Proposal for the 03 series of amendments to UN Regulation No. 118 (Burning behaviour)

"Figure 1
Specimen holder (Dimensions in millimetres)

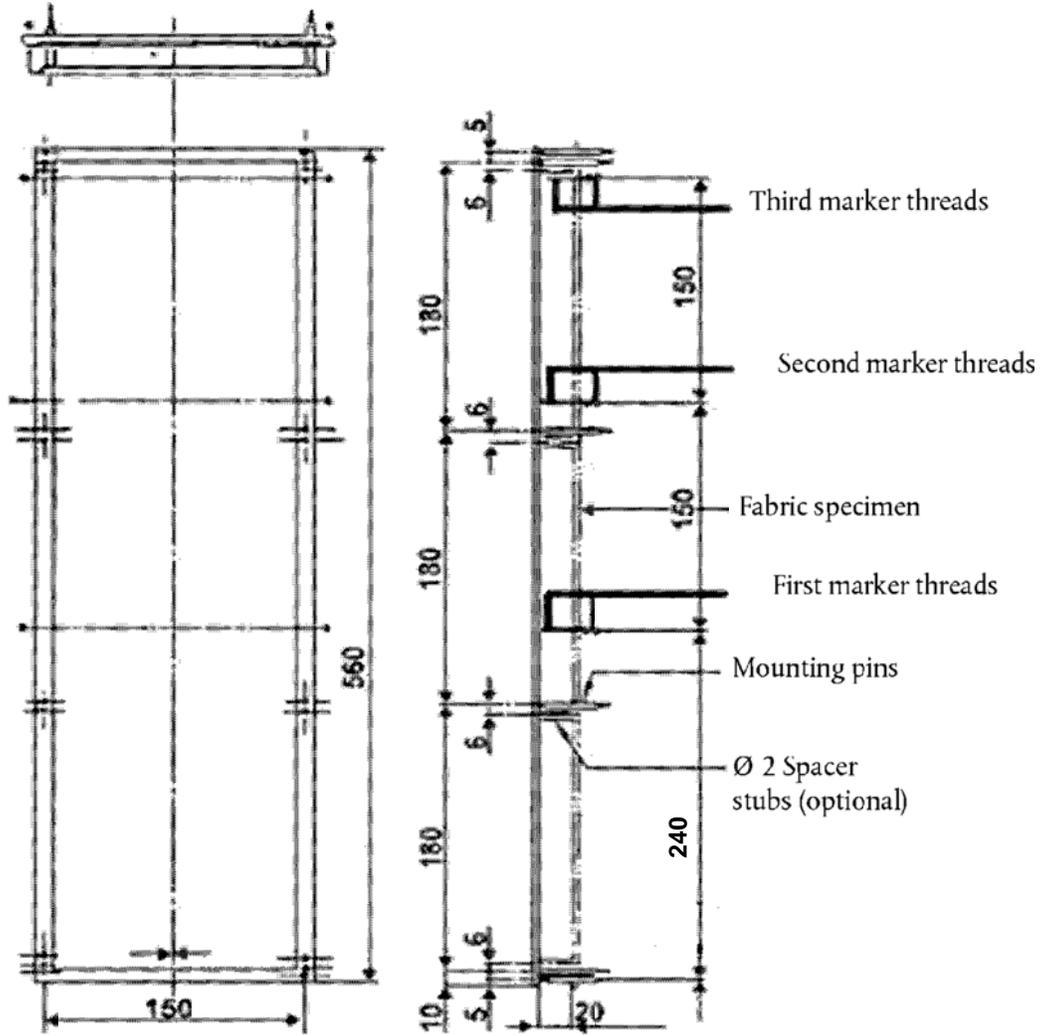
Figure 1, amend to read (removing "Burner" at the bottom and replacing "220" by "240"):

- "2.1. The specimen holder shall consist of a rectangular frame of 560 mm high and shall have two rigidly connected parallel rods spaced 150 mm apart on which pins shall be fitted for mounting the test specimen which is located in a plane at least 20 mm from the frame. The mounting pins shall be not greater than 2 mm in diameter and at least ~~27~~ 40 mm long. The pins shall be located on the parallel rods at locations shown in Figure 1. The frame shall be fitted onto a suitable support to maintain the rods in a vertical orientation during testing (for the purpose of locating the specimen on the pins in a plane away from the frame, spacer stubs 2 mm in diameter may be provided adjacent to the pins).**

The specimen holder shown in Figure 1 may be modified in width to allow the fixation of the sample.

To fix the sample in a vertical position, a support may be provided consisting of 0.25 mm diameter heat resistant wires that horizontally span the sample at 25 mm intervals along the complete height of the specimen holder. Alternatively, the sample may be fixed by additional clamps to the specimen holder."
